DESIGN REVIEW COMMITTEE

September 20, 2023 6:00 PM

AGENDA

A3.0

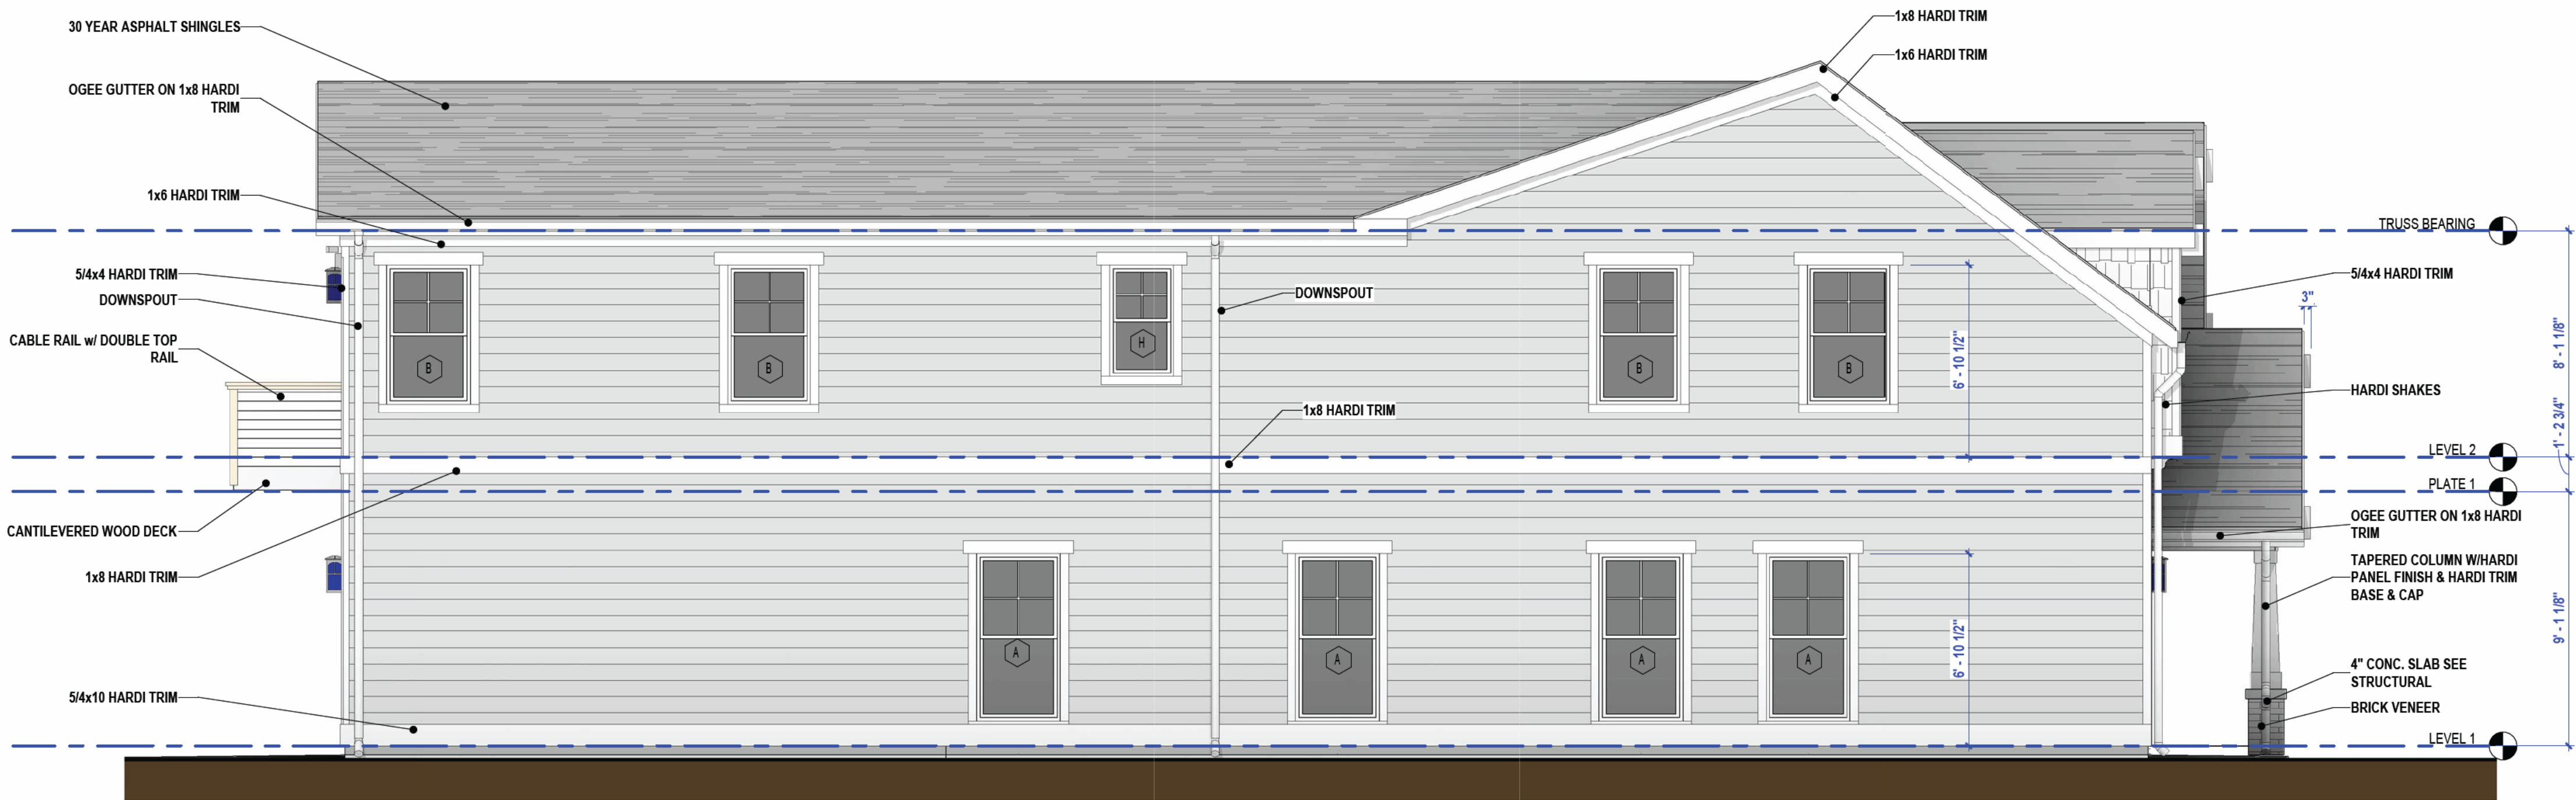
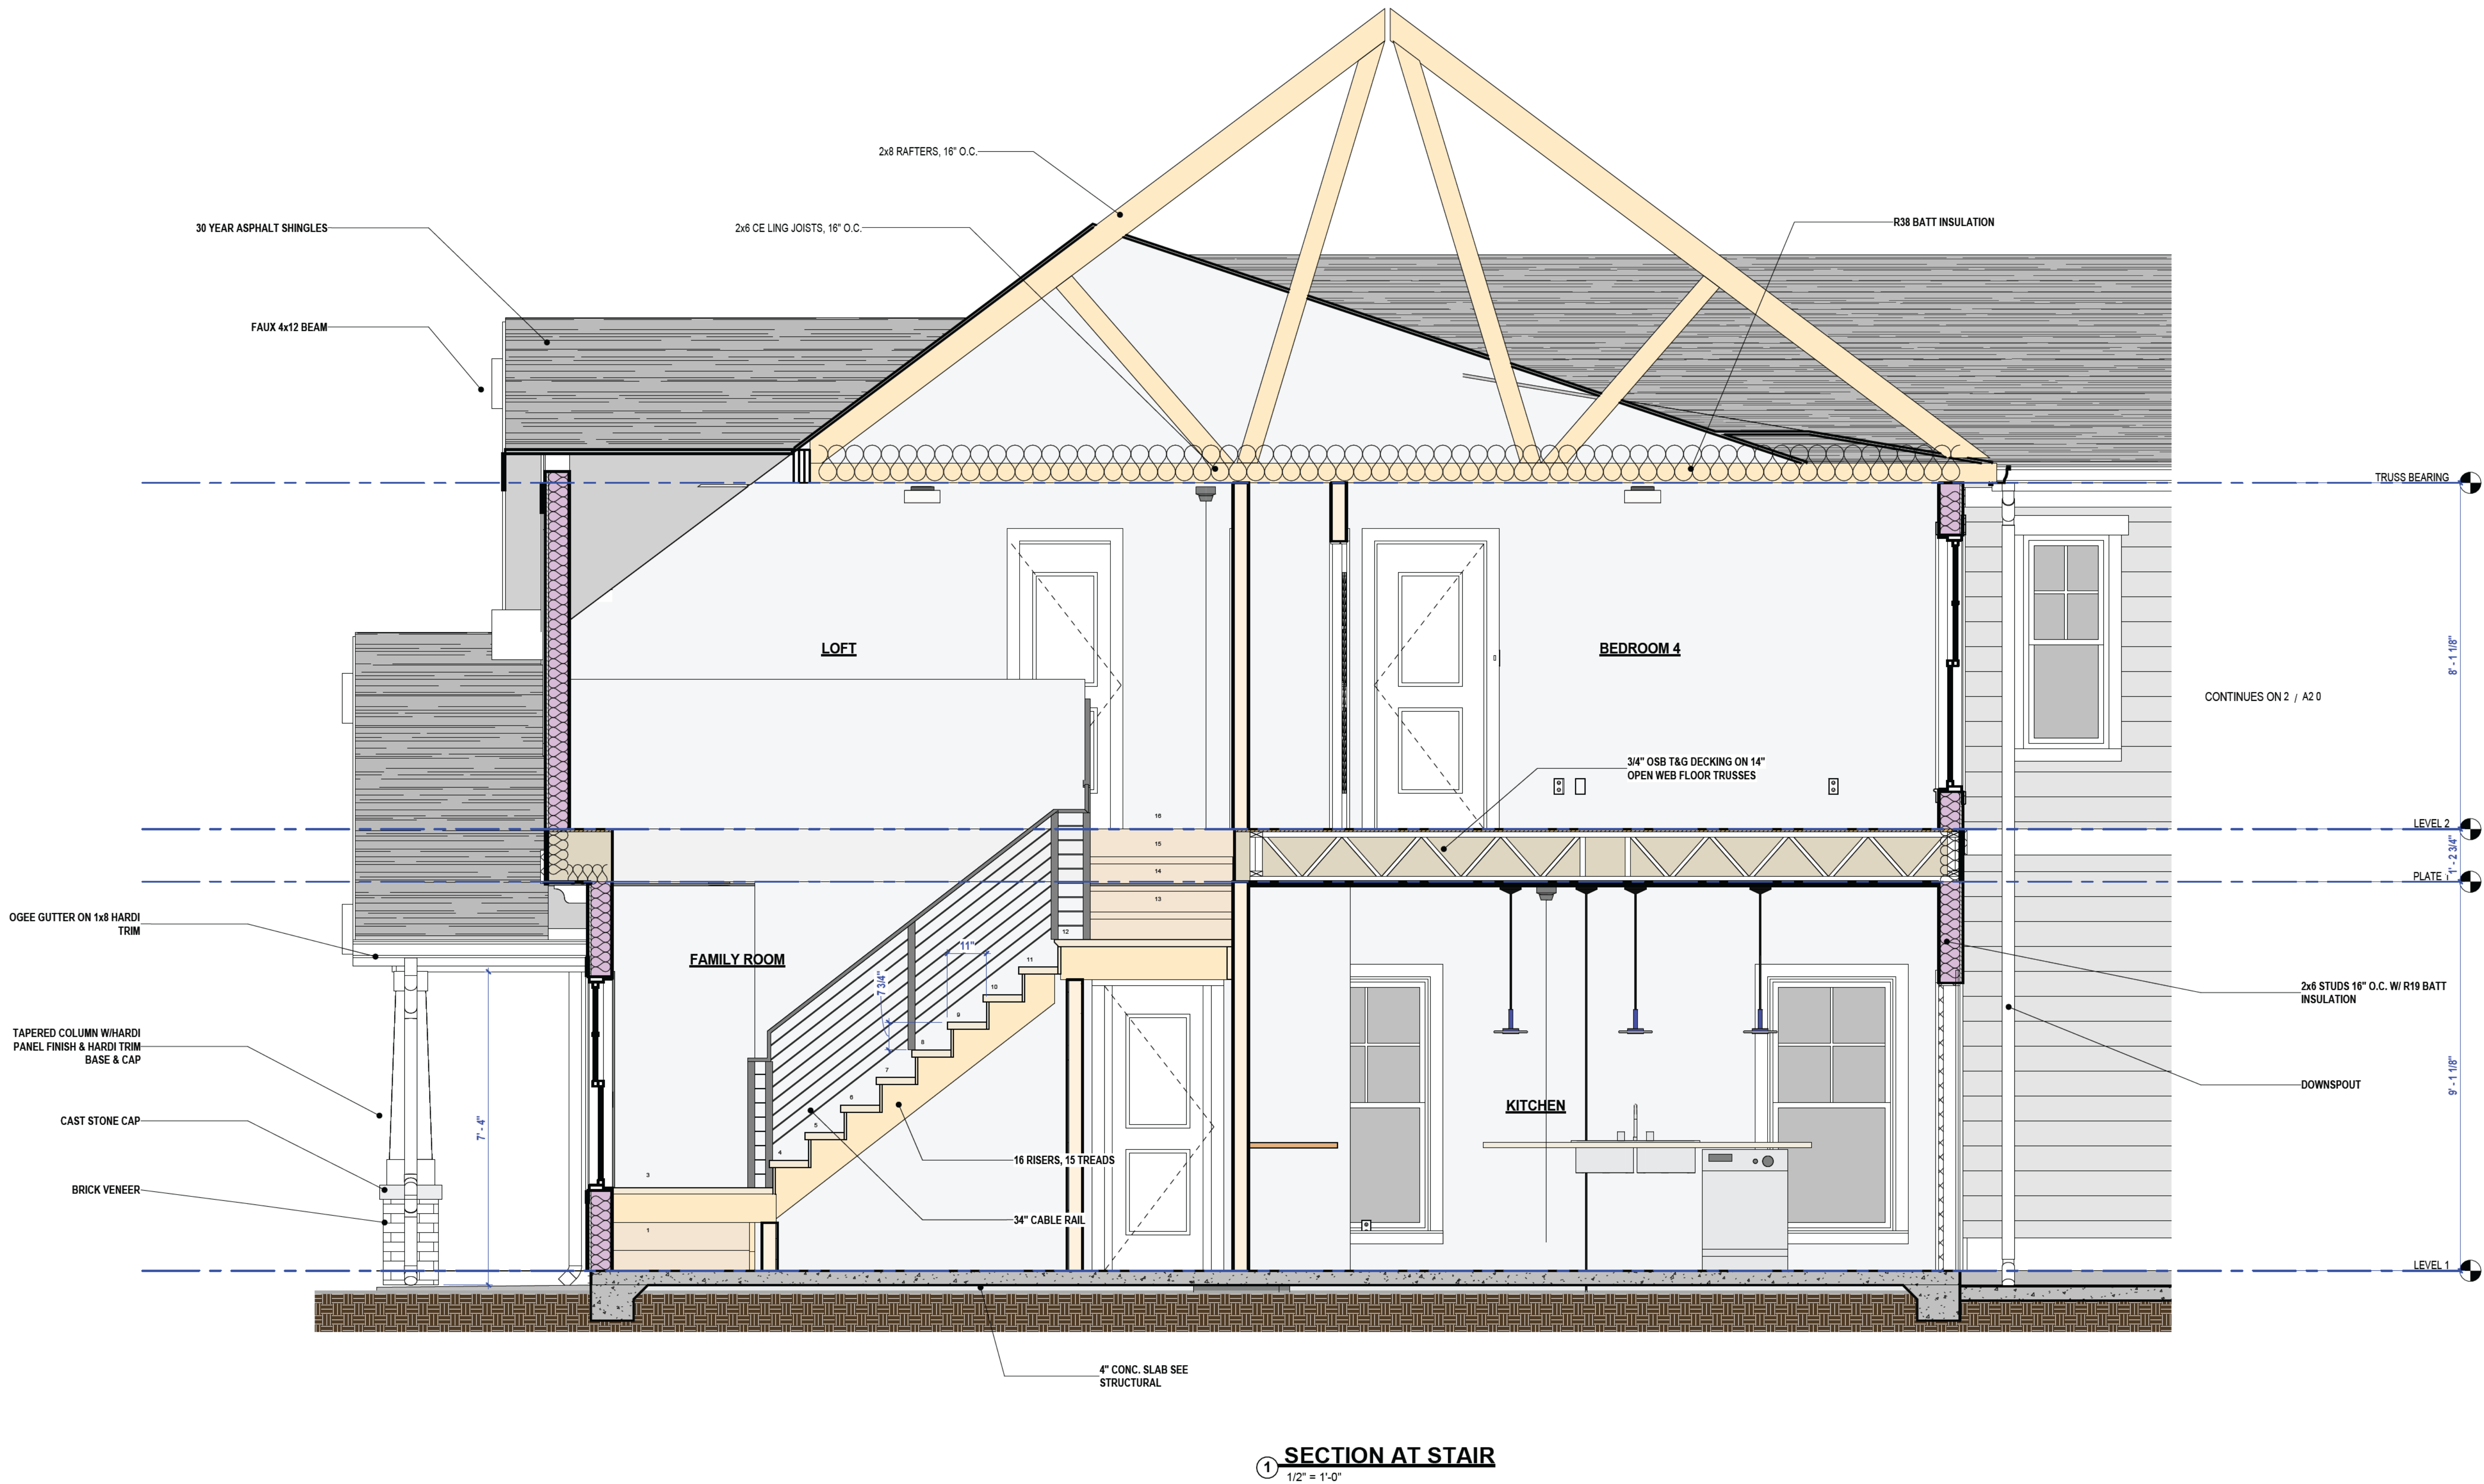
STAFF COMMENT: Ensure 12" overhang. Note: original roof line / trusses still shown on A 3.0, remove.

- Provide distinct sills.
- Address sill height.
- Remove original roof line / trusses on A 3.0.
- Rear balcony does not meet railing design requirement. Either Design Exception or rework railing to meet standards.
